<b>Device</b>	<b>C505A-4RM, C505CA-2RM/4RM/LM, C505CA-4RC</b>
<b>Marking/Step</b>	<b>Step ES-CA, CA</b>
<b>Package</b>	<b>P-MQFP-44, Bare Die</b>

This Errata Sheet describes the deviations from the current user documentation.

**CAN.4: Flowchart sequence in figure in User's Manual regarding Micro-controller handling of the Last Message Object is partly incorrect**

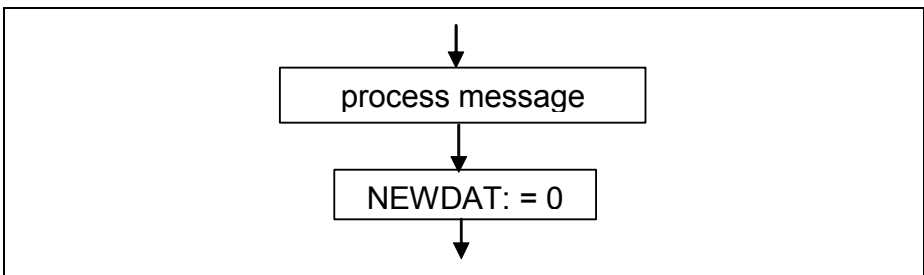
For the software flowchart figure 6-48 in User's Manual 11.97, the correct would be to first 'process message contents' and then to 'clear bit NEWDAT'.
